**Addendum No. 4**

**REQUEST FOR PROPOSALS**

**Solicitation Number: DCAM-23-AE-RFP-0001**

**ARCHITECTURAL/ENGINEERING SERVICES FOR  
RANDALL RECREATION CENTER**

**Exhibit B**  
**C4.0-114-253 SITE PLAN**

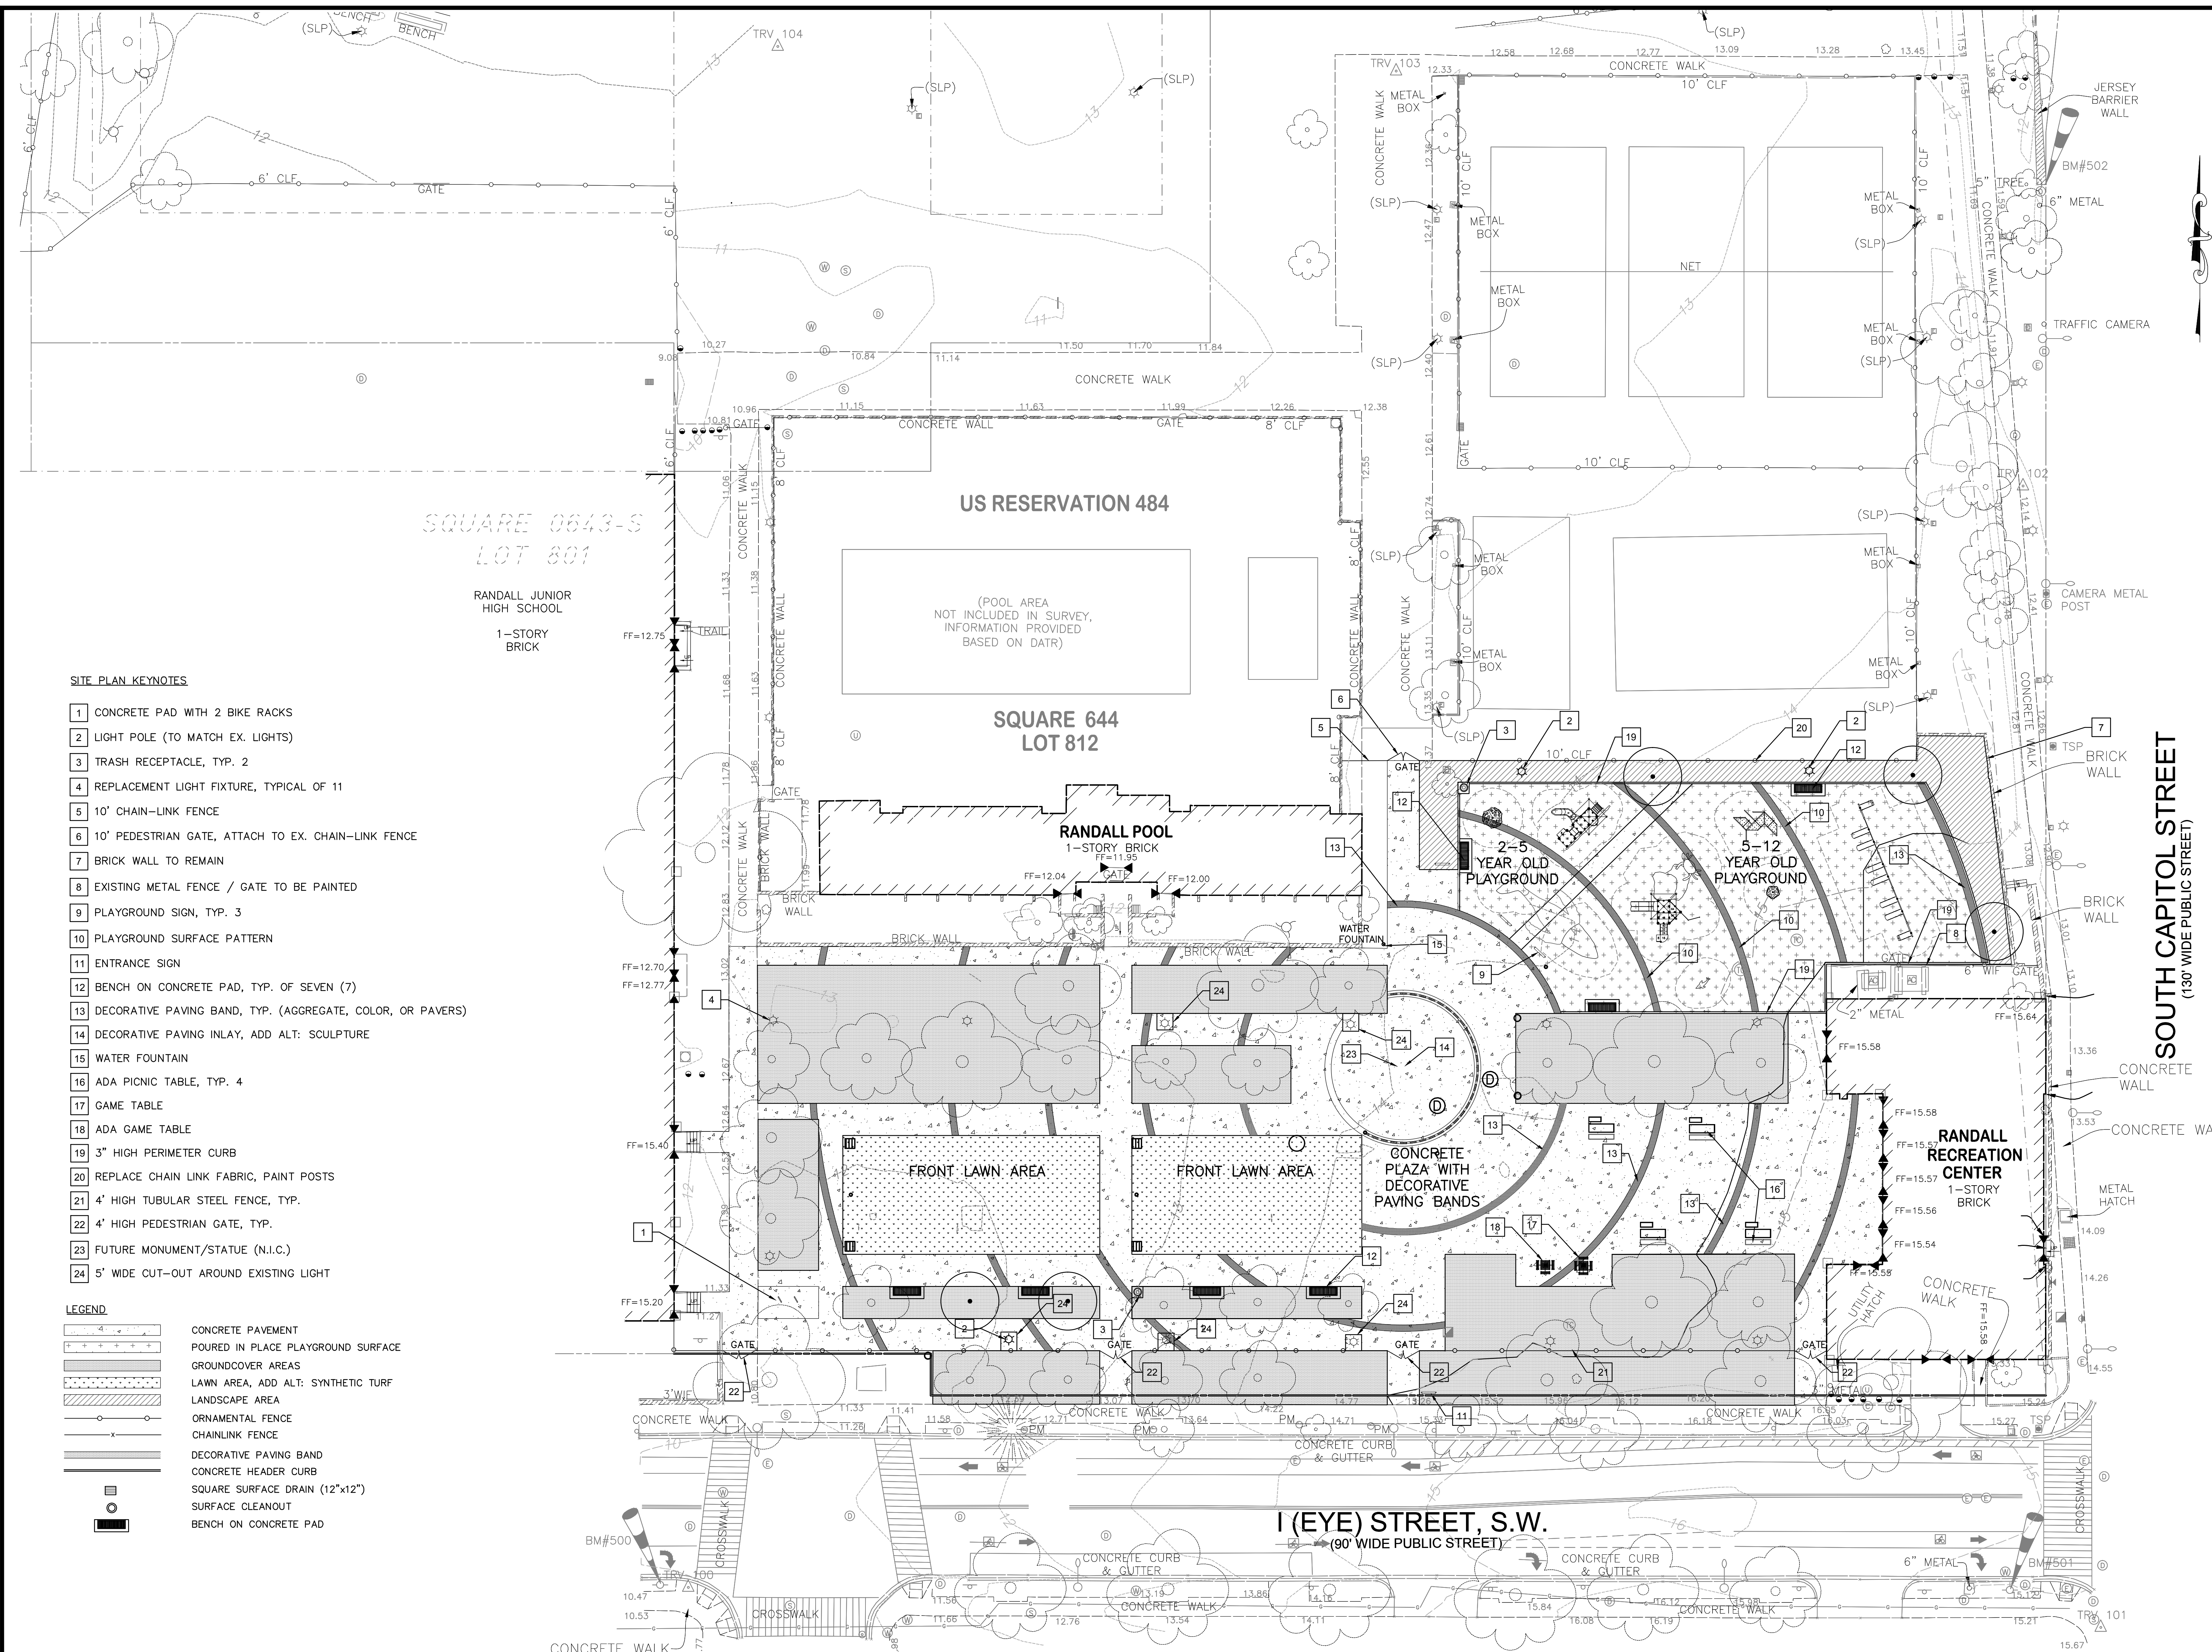
No.	Questions	Department Responses
1.	Plaza renovation: Can we design the plaza layout to enhance the historic building? For example, changing the pavement layout, greenery, and impervious surfaces? a. Based on this, do you have any exhibits which show where that existing splash pad infrastructure is located?	Yes, Keep in mind the plaza has infrastructure for a splash pad so we would not want to relocate this work already in place.  a. See <b>Exhibit B (Site Plan)</b> and <b>Exhibit C (SWM Plan)</b> of Addendum No. 4
